PUBLIC INTEREST REVIEW FOR GROUNDWATER APPLICATIONS

TO:	Water Rights Section	Date_	05/11/2015
FROM:	Groundwater Section	Phillip I. Marcy / Michael J. T	homa
SUBJECT:	Application G- 17924	Reviewer's Name Supersedes review of	12/30/2014
		1	Date of Review(s)

Applicant's Name: J. C. Watson Company County: Malheur A. GENERAL INFORMATION:

Figure 1: Hunt (1999) model results for stream depletion between the nearest proposed POD and the Owyhee R. assuming the full rate produced from this well.

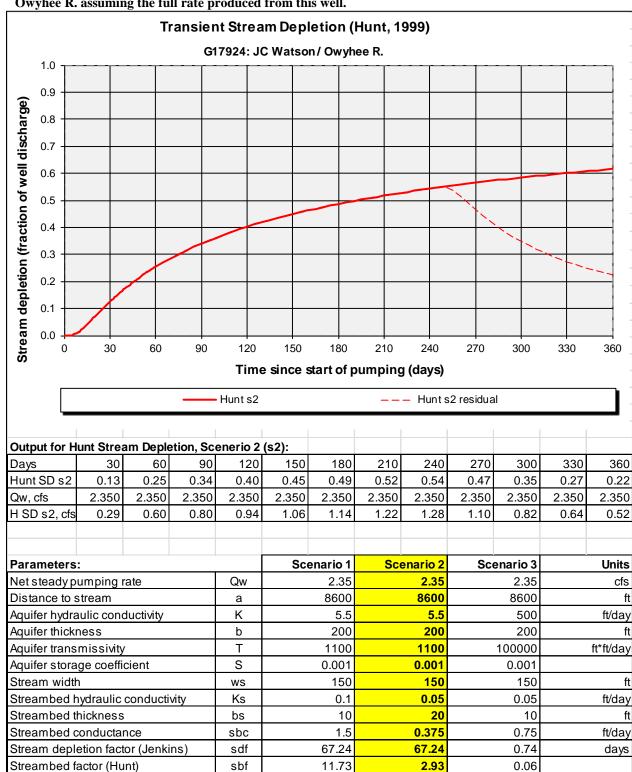
Basis for impact evaluation: The full annual duty (380 x 3 = 1140 af) divided by the period of use (245 d) was used to determine the average well pumping rate (2.35 cfs). The Hunt (1999) model was used to evaluate impacts to the Owyhee River under the "worst-case" scenario, which was considering the full rate produced from the closest well to the river, leaky-confined conditions, and using conservative parameters. This model and these results also assume that there will be no interference to the Snake River, which is of similar distance to the wells and so would likely absorb some of the impacts from pumping. Even under this worst-case scenario, interference is < 1 % of flows in the Owyhee R. and so will not trigger PSI. PSI to the Snake River was not modeled but historic low flow values in the Snake R. are much greater than 1% of the full rate (see Figure 2) and so PSI would not be triggered under any amount of interference.

Figure 3: Location Map

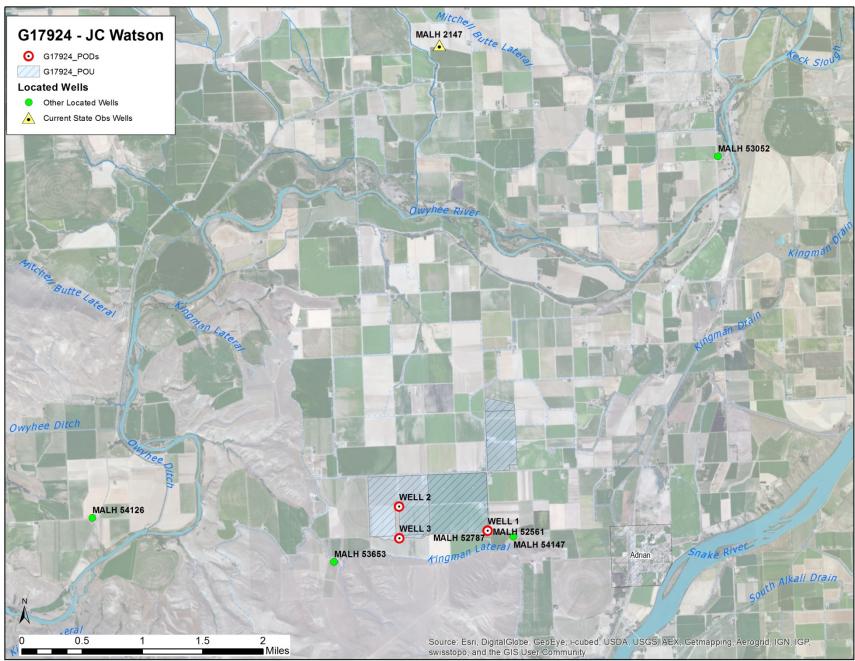
Basis for aquifer hydraulic connection evaluation: Well #1 is closer to the Snake R. which is east of the PODs and Wells #2 and #3 are closer to the Owyhee R., which is located west and north of the PODs (see Figure 3). The aquifer is unconfined to leaky-confined and limited head data imply that general groundwater flow is from west and south flowing north and east toward the Snake R. In general the aquifer in the vicinity of the PODs is probably more strongly connected to the Snake R. than the Owyhee R. as it is the regional groundwater discharge. However, as there is no WAB for the Snake R. and since the Owyhee R. has lower flows, interference with the Owyhee R. was investigated in C4a below.

The three proposed PODs are located on a sloping plain extending out from the sedimentary and volcanic uplands near the Owyhee Reservoir and sloping northeast toward the Owyhee and Snake Rivers (Figure 3). There is limited groundwater data available in this area but these data and the department's conceptual model suggests that groundwater flow mimics topography and flows out of the uplands east toward the Snake River and north-northeast toward the lowest section of the Owyhee River. The proposed PODs are within the Owyhee R. WAB but there is a 200-400 ft ridge separating the PODs and the Owyhee R. at the shortest distance between the proposed PODs and the river. It is more likely that the wells are more directly hydraulically connected to the Snake R. owing to this ridge and general groundwater flow direction. However, impacts and PSI were still evaluated for the Owyhee R. and the model results indicate no PSI under a worst-case scenario (i.e., full rate from one well, using the well closest to the river, conservative parameters, impacting only the Owyhee R.). Impacts and PSI to the Snake R. are also not substantial as minimum daily discharge from the past 36 years in the Snake River at Nyssa (USGS Gage #13213100) is 4240 cfs (Figure 2). 1 % of this minimum flow (42.4 cfs) is far greater than the full rate requested on the application so there will not be PSI with the Snake R. under any amount of interference.

Figure 4: MALH 2147 Water Level Data

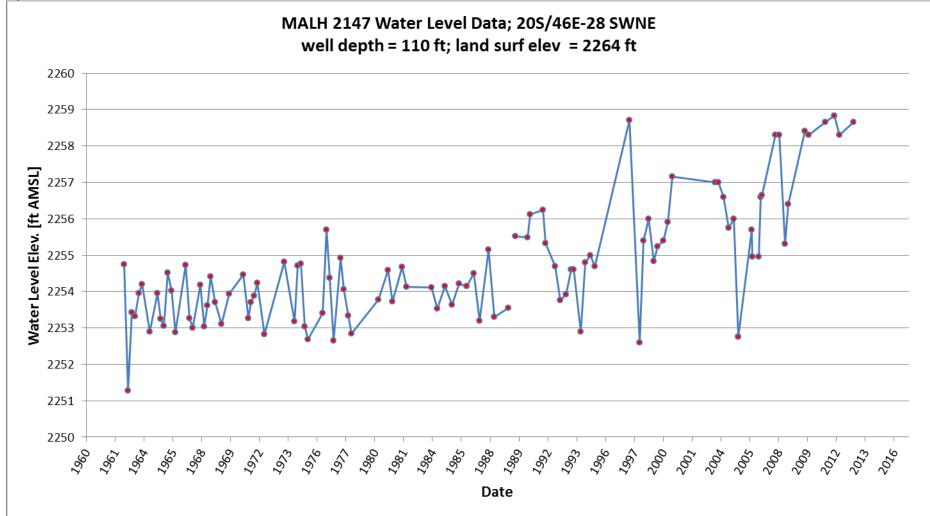
Regarding Appropriation: There are few wells in the area that have long-term water level data. The closest is MALH 2147 which is > 4 mi to the north of the proposed PODs. This well shows stable long-term water levels (see Figure 4) but may not be representative of the area near the PODs.

Figure 6- The calculated effects of pumping MALH 52787 at the maximum requested rate on application G-17924 on nearby MALH 54147. Estimated interference at the neighboring well ranges from 5.19 feet to 28.56 feet under a range of possible aquifer conditions.

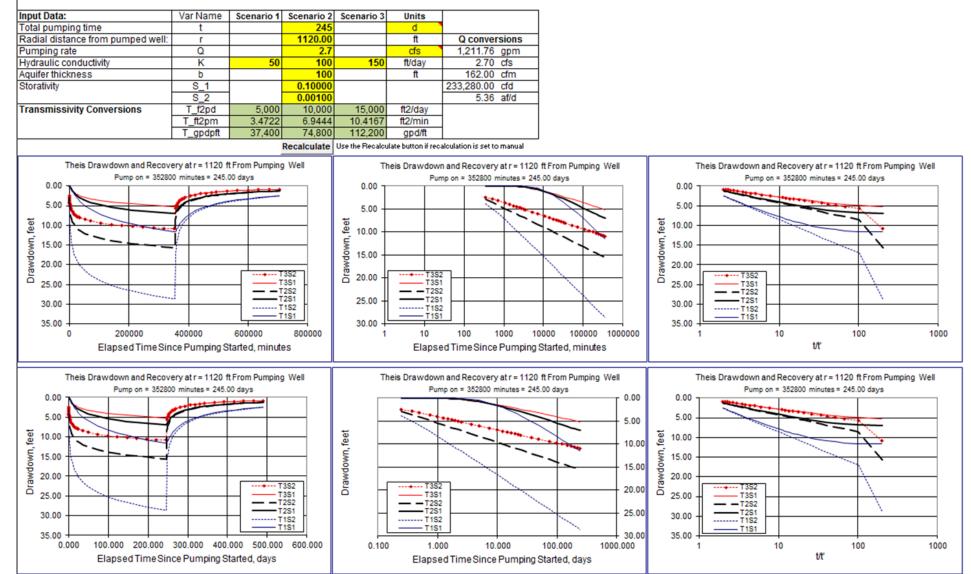
Regarding Injury: Local well logs suggest that the aquifer utilized by MALH 52787 (Well 1 on application) is relatively thin (see logs MALH 54147, MALH 2248, MALH 52561). Recent pump test data collected from nearby MALH 54147 indicate transmissivity in this aquifer ranges from about 4,700 to 5,700 ft²/day, which can facilitate extensive drawdown in the vicinity of the pumping well in a leaky-confined system as described by Gannett (1990). A calculation of expected drawdown at MALH 54147 due to pumping at MALH 52787 was performed using the Theis non-equilibrium function (1941), resulting in a range of values from 5.19 to 28.56 feet (Figure 6). Due to the possibility of extensive drawdown, and limited thickness of the aquifer, a modified annual measurement condition should be applied to this permit should it be issued (see C6). Due to increased groundwater use in the area, and the size of the proposed use, the Water Resources Department wants to better monitor groundwater levels in the aquifer. Therefore, a special condition shall also be applied allowing the department access to nearby unused well MALH 52561 on the applicant's property.

Special Condition: If a permit is issued, the applicant shall grant the Water Resources Department access to unused well MALH 52561 for use as a monitoring well.
